# TERAHOP

## Refine the Rx Sensitivity/Tx OMA for DR and FR4-500 D3.0 Comment # I-72, I-73

Michael He, Penny Xu, Tom Liu, and Rang-Chen(Ryan) Yu

Figure 180-3—OMA<sub>outer</sub> each lane (max) and OMA<sub>outer</sub> each lane (min) versus max(TECQ, TDECQ)

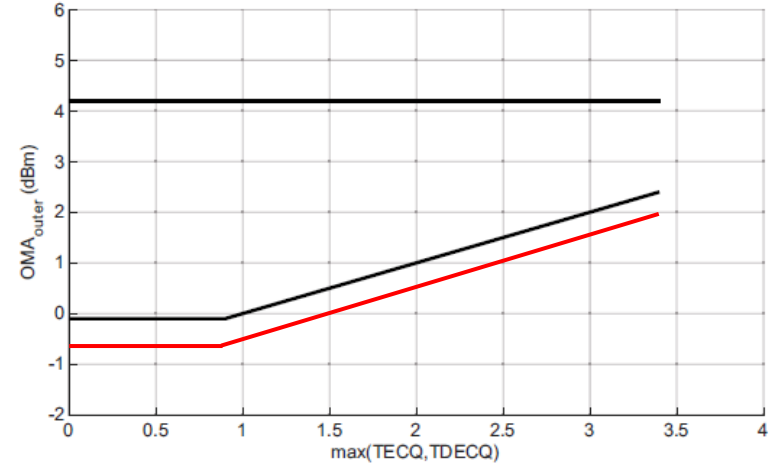
# Suggested remedy for DR Tx (reduce 0.6dB)

Description	Reference	200GBASE-DR1	400GBASE-DR2 800GBASE-DR4 1.6TBASE-DR8	Unit
Signaling rate, each lane (range)	—	106.25 ± 50 ppm		GBd
Modulation format	—	PAM4		—
Lane wavelength (range)	180.9.3	1304.5 to 1317.5		nm
Side-mode suppression ratio (SMSR), each lane (min)	180.9.3	30		dB
Average launch power, each lane (max)	180.9.4	4		dBm
Average launch power, each lane <sup>a</sup> (min)	180.9.4	<del>-3.1</del> <sup>b</sup> -3.7		dBm
Outer optical modulation amplitude (OMA <sub>outer</sub> ), each lane (max)	180.9.5	4.2		dBm
Outer optical modulation amplitude (OMA <sub>outer</sub> ), each lane (min) for max(TECQ, TDECQ) < 0.9 dB for 0.9 dB ≤ max(TECQ, TDECQ) ≤ 3.4 dB	180.9.5	<del>-0.1</del> -0.7 -1.6 -1+ max(TECQ, TDECQ)		dBm dBm

**Figure 180–4—Receiver sensitivity (OMA<sub>outer</sub>), each lane (max)**

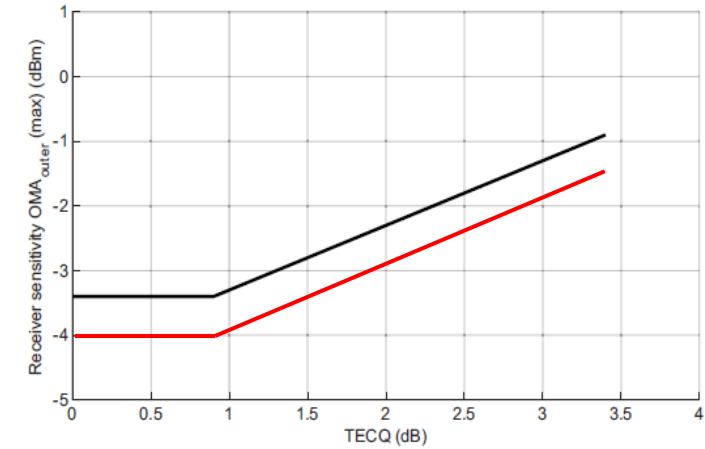
# Suggested remedy for DR Rx (reduce 0.6dB)

Description	Reference	Value	Unit
Receiver sensitivity (OMA <sub>outer</sub> ), each lane <sup>c</sup> (max) for TECQ < 0.9 dB for 0.9 dB ≤ TECQ ≤ SECQ	180.9.15	<del>-3.4 -4.0</del> -4.9 -4.3 + TECQ	dBm
Stressed receiver sensitivity (OMA <sub>outer</sub> ), each lane <sup>c</sup> (max)	180.9.16	<del>-0.9 -1.5</del>	dBm
Conditions of stressed receiver sensitivity test <sup>d</sup> :			
Stressed eye closure for PAM4 (SECQ), lane under test	—	3.4	dB
OMA <sub>outer</sub> of each aggressor lane <sup>e</sup>	—	4.2	dBm

Figure 181-3—OMA<sub>outer</sub> each lane (max) and OMA<sub>outer</sub> each lane (min) versus max(TECQ, TDECQ)

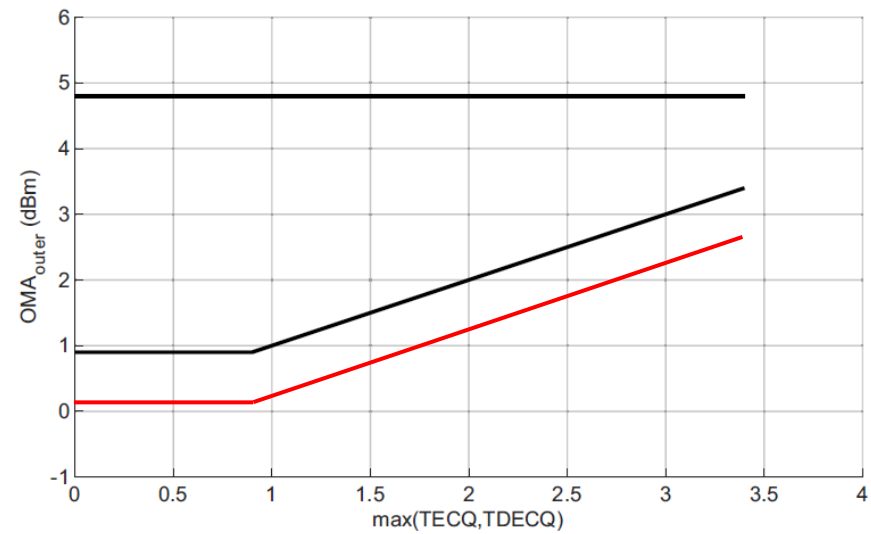
# Suggested remedy for FR4-500 Tx (reduce 0.8dB)

Description	Reference	800GBASE-FR4-500	Unit
Signaling rate, each lane (range)	—	106.25 ± 50 ppm	GBd
Modulation format	—	PAM4	—
Lane wavelengths (range)	181.9.3	1264.5 to 1277.5 1284.5 to 1297.5 1304.5 to 1317.5 1324.5 to 1337.5	nm
Side-mode suppression ratio (SMSR), each lane (min)	181.9.3	30	dB
Total average launch power (max)	181.9.4	10.9	dBm
Average launch power, each lane (max)		4.9	dBm
Average launch power, each lane <sup>a</sup> (min)		-2.1 <sup>b</sup> -2.9	dBm
Outer optical modulation amplitude (OMA <sub>outer</sub> ), each lane (max)	181.9.5	4.8	dBm
Outer optical modulation amplitude (OMA <sub>outer</sub> ), each lane (min) for max(TECQ, TDECQ) < 0.9 dB for 0.9 dB ≤ max(TECQ, TDECQ) ≤ 3.4 dB		0.9 0.1 -0.8 + max(TECQ, TDECQ)	dBm dBm

Figure 181-4—Receiver sensitivity (OMA<sub>outer</sub>), each lane (max)

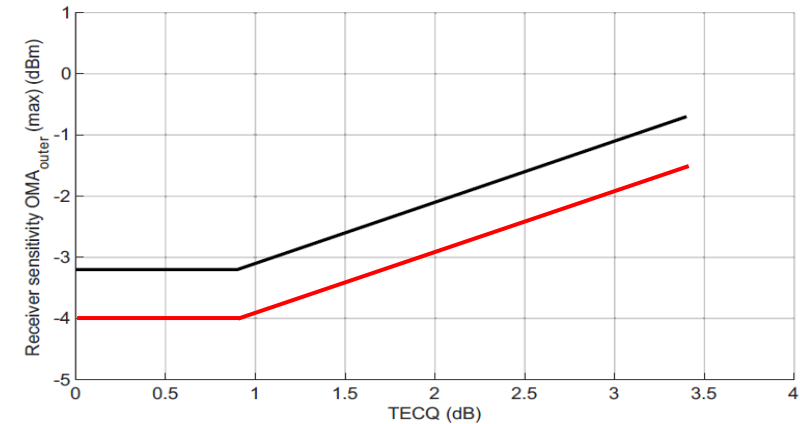
# Suggested remedy for FR4-500 Rx (reduce 0.8dB)

Description	Reference	800GBASE-FR4-500	Unit
Signaling rate, each lane (range)	—	106.25 ± 50 ppm	GBd
Modulation format	—	PAM4	—
Lane wavelengths (range)	181.9.3	1264.5 to 1277.5 1284.5 to 1297.5 1304.5 to 1317.5 1324.5 to 1337.5	nm
Damage threshold <sup>a</sup> , each lane	—	5.9	dBm
Average receive power, each lane (max)	—	4.9	dBm
Average receive power, each lane <sup>b</sup> (min)	—	-5.6 -6.4	dBm
Receive power (OMA <sub>outer</sub> ), each lane (max)	—	4.8	dBm
Difference in receive power between any two lanes (OMA <sub>outer</sub> ) (max)	—	4.1	dB
Receiver reflectance (max)	—	-26	dB
Receiver sensitivity (OMA <sub>outer</sub> ), each lane <sup>c</sup> (max) for TECQ < 0.9 dB for 0.9 dB ≤ TECQ ≤ SECQ	181.9.15	-3.2 -4.0 -4.9 -4.1 + TECQ	dBm dBm
Stressed receiver sensitivity (OMA <sub>outer</sub> ), each lane <sup>c</sup> (max)	181.9.16	-0.7 -1.5	dBm
Conditions of stressed receiver sensitivity test: <sup>d</sup>
